Group of Experts on Road Signs and Signals

Non-Convention signs – zero and low emission zonal signs

Submitted by Denmark

Conclusions from the informal meeting on Tuesday 22 November 2022 between the chairman Karel Hofman and Denmark

Sign for Zero emission zone (zonal validity)

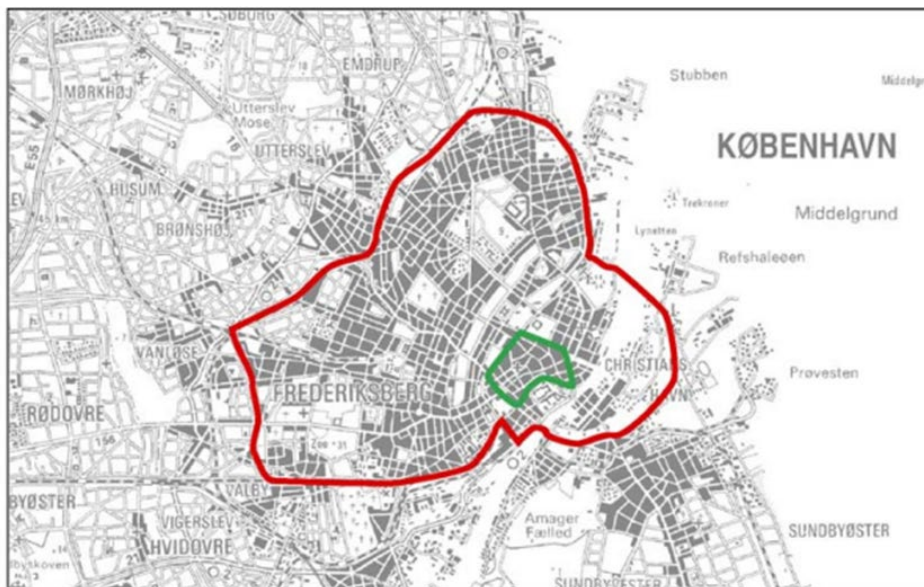
Proposal for a new sign in the convention only for low emission zones and zero emissions zones.

It should be possible to add the text “**Zero emission zone**” or “**Low emission zone**” on an additional panel or on the sign itself.

The national legislation must state which vehicles can possibly be exempted with regard to the Zero emission zone or Low emission zone. For example, the armed forces, the police, the rescue services or similar emergency services.
